Annex 113A Description of cable clamp and test setup

113A.1 Overview

Figure 113A-3 - Cable clamp validation test configuration

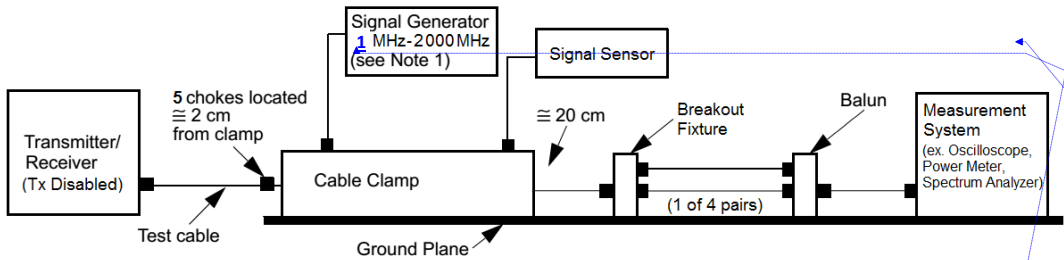
Comment [CPR3]: Ad hoc discussion focused on how to generalize this description. 30m was selected as it is the max link segment for 40GBASE-T; is this appropriate for other PHY types? (i.e. max link segment for other rates/PHYs). Note that corresponding IEC tests accommodate other lengths, but is it necessary? Noting that 30m is the upper bound for 25/40; the analog would be 100m on 10G. Annex 40B calls out “category 5 balanced cable at least 30m long.” We can take advantage of this length – 30m provides happy coincidence and will be retained.

Comment [CPR4]: Ad hoc discussion concerned using ferrites that would allow a significant gap between the I.D. and the cable. The inner diameter was re-written with language indicating that the I.D. should be suitable and fit over the category being used for the test; something like “appropriate for the cable used for the test.”

Comment [CPR5]: Restored 4GHz minimum bandwidth since we are measuring a 2GHz signal.

Comment [CPR7]: Reverted to the 20MHz defined in Annex 40B for future use with 803.bz. 80MHz for P8023bq was selected since it was the minimum frequency being tested; with a lower "generic" range of 1MHz we can go back to 20MHz.

Comment [CPR8]: Suggest something like "consistent with good RF measurement practices." That seems to be the winner. Or just state "direct contact".

Figure 113A-4 - Cable clamp test configuration

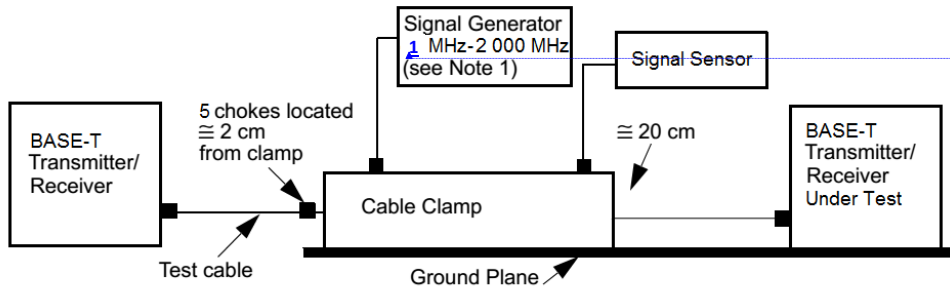
Comment [CPR9]: Ad hoc discussion suggested including a comment in the previous section noting that the same configuration should be used for both validation and configuration.

Comment [CPR10]: Original commenter's input: It's position here makes it unclear if this correction applies above or below or both. Also, earlier submissions indicated doing the correction based on measurement with the cabling and choke. Also power correction is called into question based on Moffitt initial chamber comparison submission. All this needs to be resolved.

Comment [CPR11]: Restored original tile for general usage.

Comment [CPR12]: [Commenters input: adjusted needs a clear explanation]. The ad hoc needed clarification on this comment, but I believe that this refers to the "above or below". General interpretation is that adjusted is w/o the cable; perhaps the suggested text is better. For further discussion

Comment [CPR13]: This add is covered in 113.5.4.3 with text that aligns with EMI operational requirements; striking to allow flexibility for different operational or pass/fail requirements in other clauses.

Clarifying comments after the ad hoc:

- Where does the correction apply?
 - This note follows the original positioning and text of Annex 40B. Note 1 has been interpreted as verifying the response of the unloaded/no cable clamp before performing the validation check. Therefore, the note applies to the validation procedure.

- The normative specification states that the source power is calibrated so that the signal power measured at the output of the clamp does not exceed a specified maximum; this is in fact the calibration that is performed; i.e. measure the response with no cable inserted.

- The suggested reference to 113A.1 seems unclear; the proposed text is intended to better indicate that this is to be performed prior to testing as well.

- Correction with cable and chokes?
 - Earlier P802.3bq and recent P802.3bz contributions do show that the overall system response is different when calibrated with/without the cable inserted in the clamp. However, given that the intent of the test is to align with regulatory testing, note that the EMI chamber field calibration does not attempt to assure a constant coupled signal level - the cabling/interconnect/grounding/shielding elements respond to a field calibrated for a specific power level at fixed points in space. Hence the similar approach of calibrating to a fixed "no cable" injected source power.
